BRIEFING SUMMARY SHEET

DEVELOPMENT ASSESSMENT CASE NUMBER: CD-2019-0006 – 614 S. 1st Street PUD

Presentation of a Development Assessment Report for the 614 South 1st Street Planned Unit Development (PUD), located at 614 South 1st Street, within the East Bouldin Creek Watershed.

MASTER REVIEW REPORT

PROJECT:	TIMBERCREEK PUD 614 S. 1ST STREET AUSTIN, TRAVIS COUNTY, TEXAS, 78704
SHEET TITLE:	LAND USE NOTES

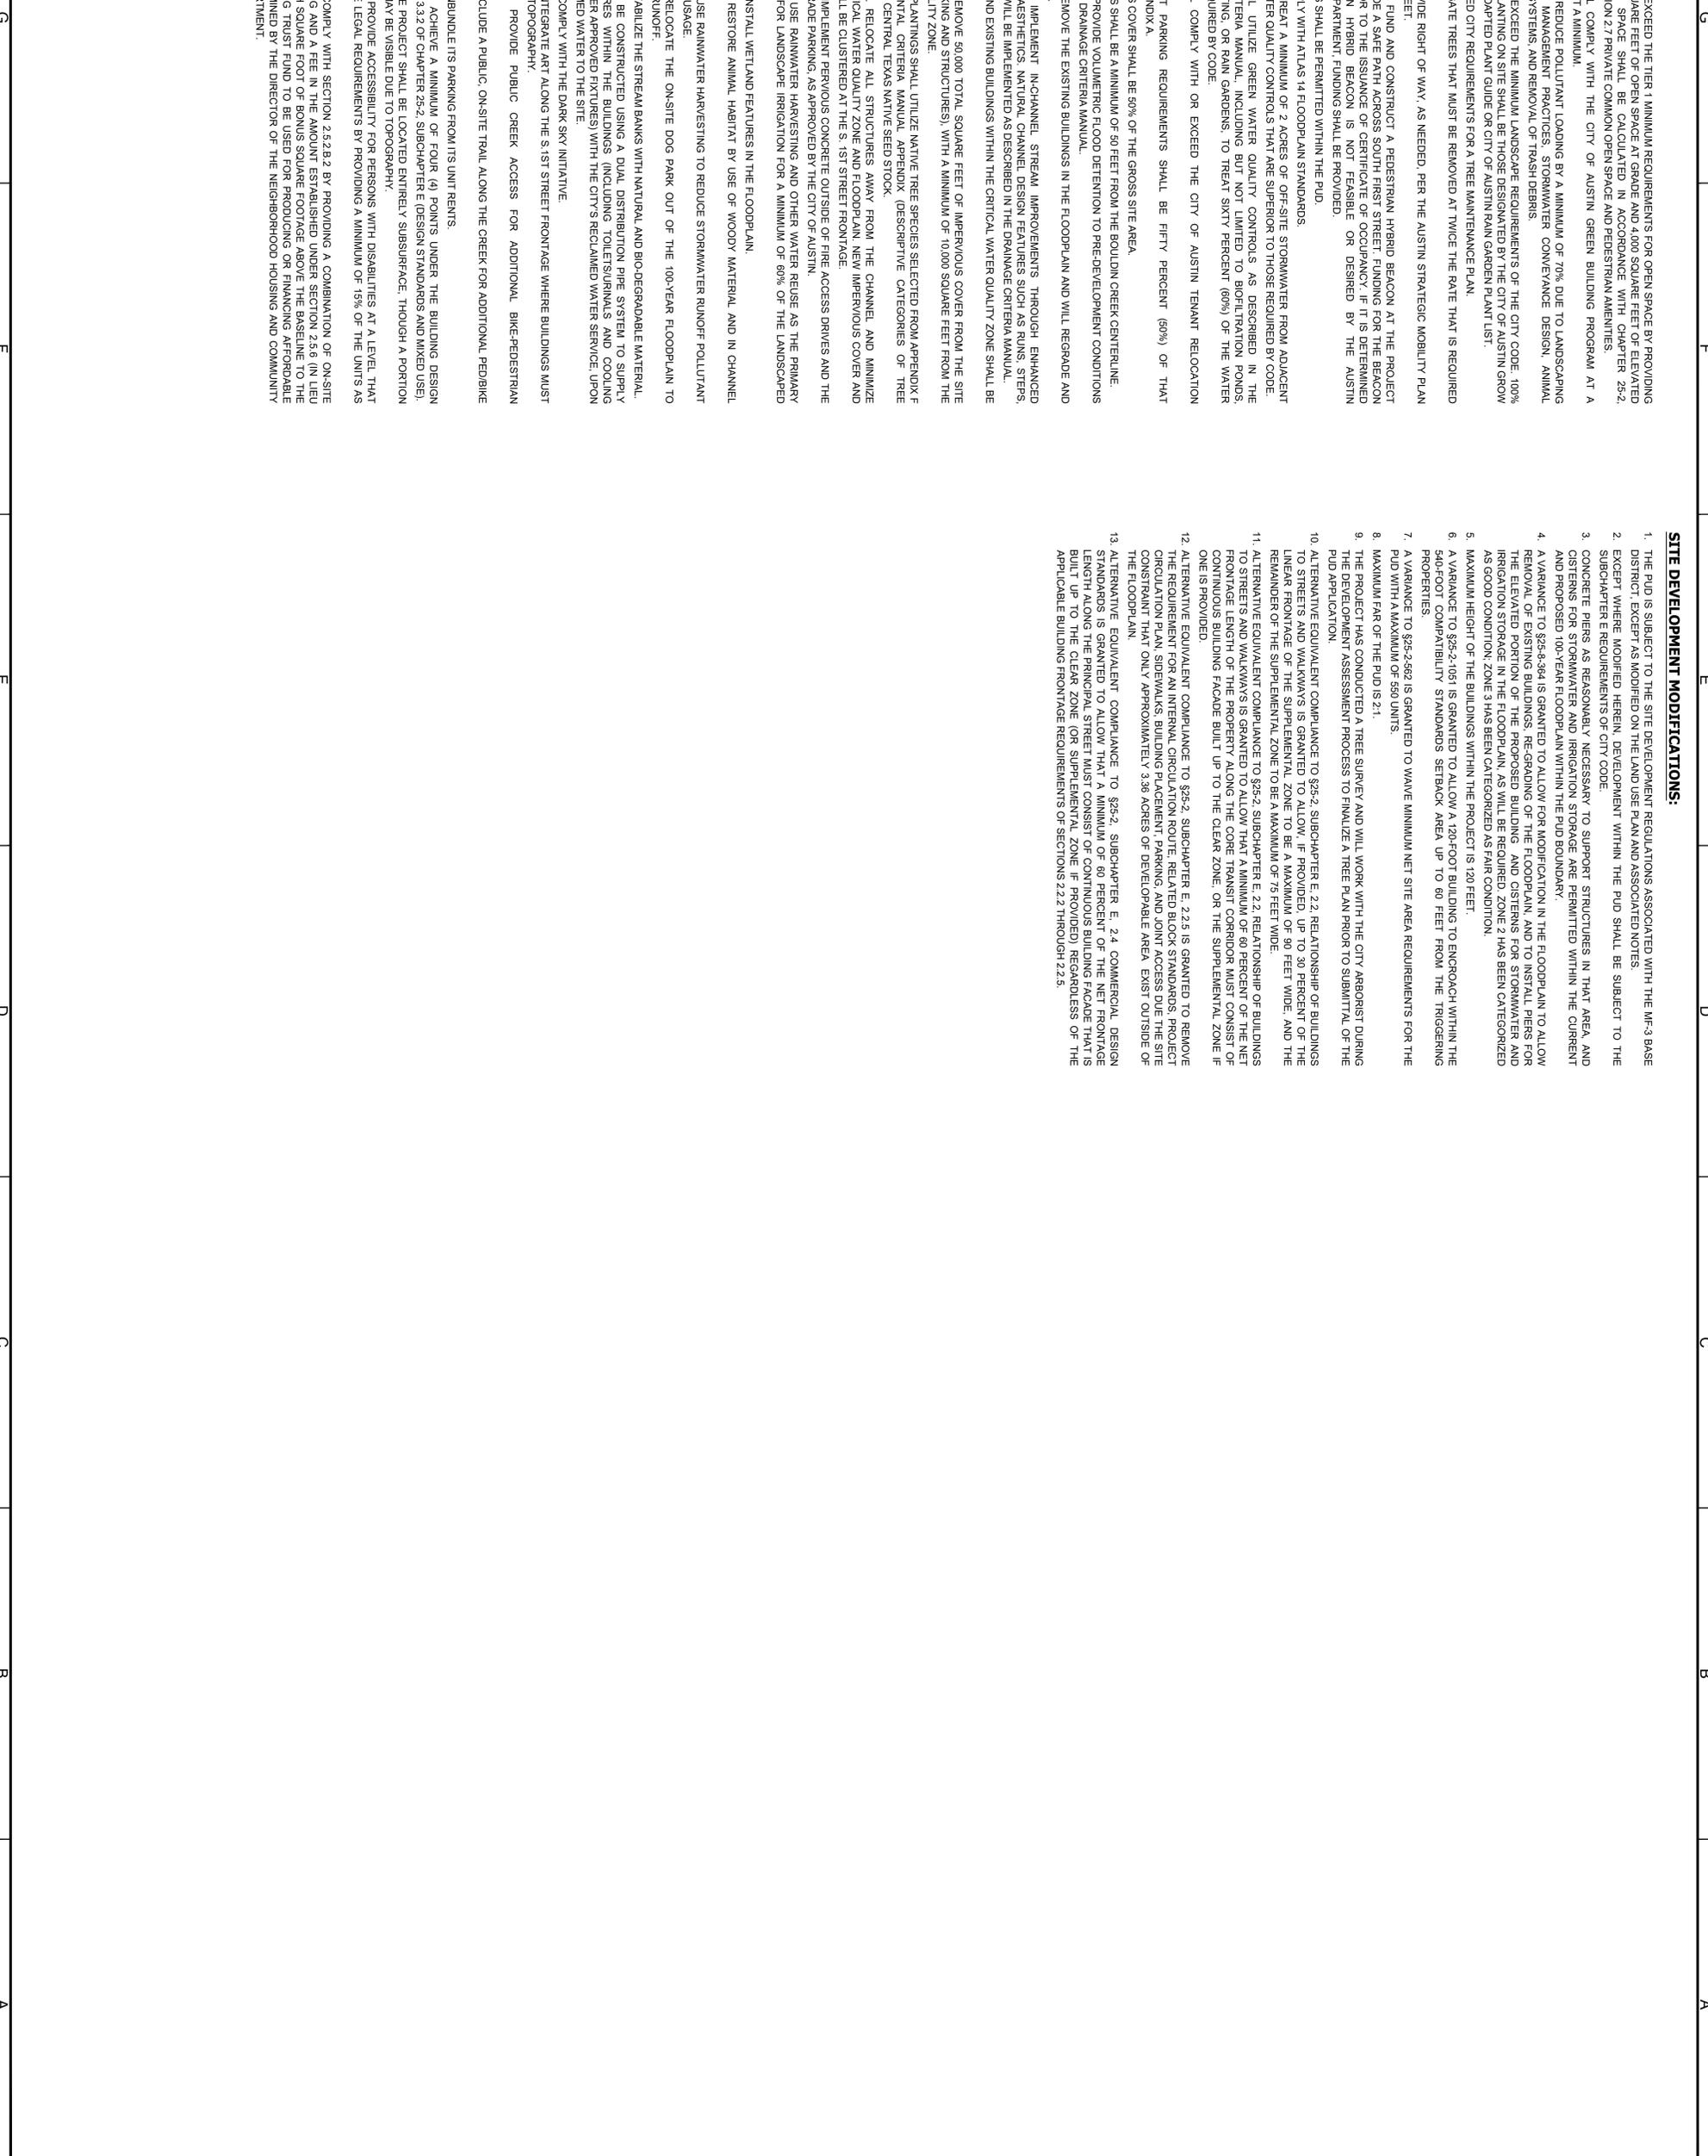
TR 3. Revise notes #34 and #35 in PUD application to specify an 8' wide accessible trail.

- ZN 2. Please remove the “Land Use Notes” sheet and make sure “PUD Notes” and “Site Development Modifications” are captured within the “Tier 1 and 2 Compliance” and “PUD Variances” tables. PUD notes may be required further along in the process and shall be determined once the Tier 1 and Tier 2 Compliance and PUD Variances tables are finalized.
